R. E. GINNA NUCLEAR POWER PLANT

AMENDMENT TO FACILITY OPERATING LICENSE

Amendment No. 48
License No. DPR-18

ATTACHMENT TO LICENSE AMENDMENT NO. 48

Figure 3.1-1: Ginna Reactor Vessel Heatup Limitations Applicable for the first 21 EFPY using Reg Guide 1.99, Rev. 2

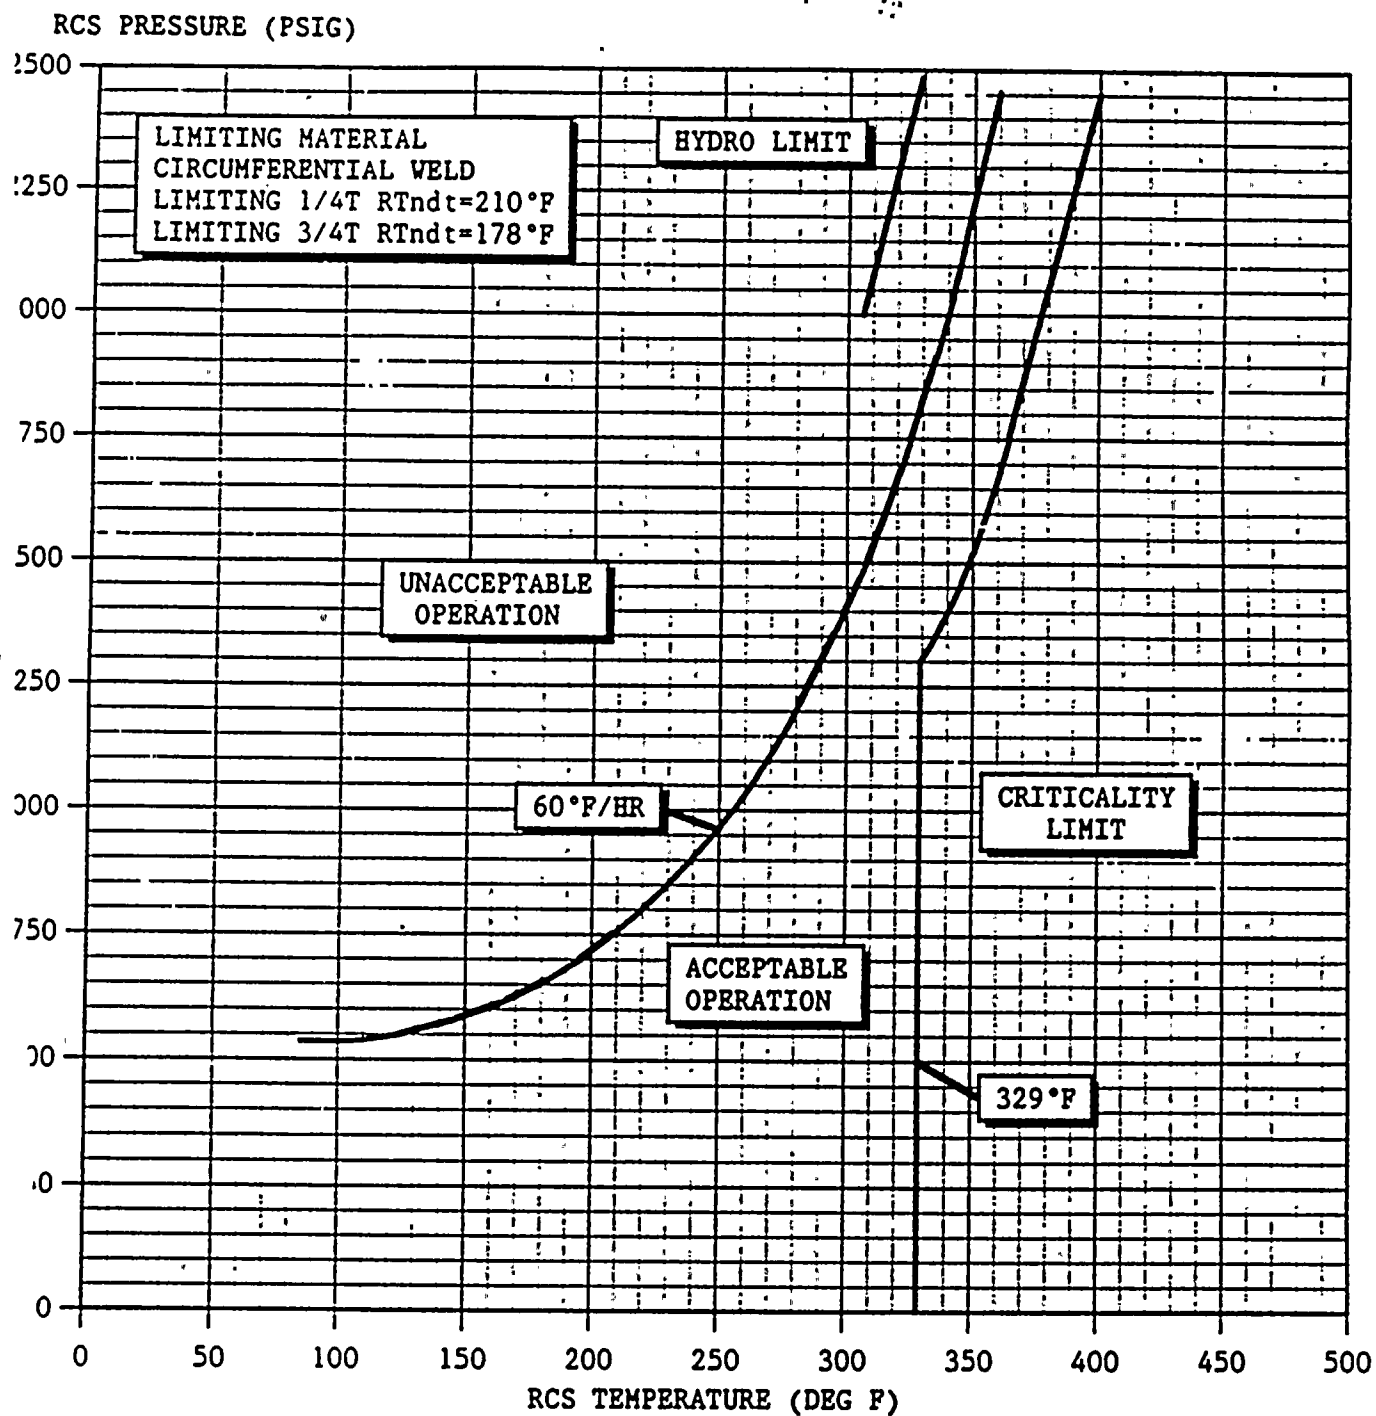
3.1.2.1 The reactor coolant temperature and pressure and system heatup and cooldown rates (with the exception of the pressurizer) shall be limited in accordance with Figures 3.1-1 and 3.1-2 for the first 21.0 effective full power years.

- a. Allowable combinations of pressure and temperature for specific temperature change rates are below and to the right of the limit lines shown. The heatup and cooldown rates shall not exceed 60°F/hr and 100°/hr, respectively. Limit lines for cooldown rates between those presented may be obtained by interpolation.

- b. Figures 3.1-1 and 3.1-2 define limits to assure prevention of non-ductile failure only. The limit lines shown in Figures 3.1-1 and 3.1-2 shall be recalculated periodically using methods discussed in the Basis Section.

- c. If the limits on Figures 3.1-1 and 3.1-2 are exceeded, restore the temperature and/or pressure to within the limit within 30 minutes; and either
 - 1) within 6 hours, perform an engineering evaluation to determine the effects of the out-of-limit condition on the structural integrity of the Reactor Coolant System and determine that the Reactor Coolant System remains acceptable for continued operation, or
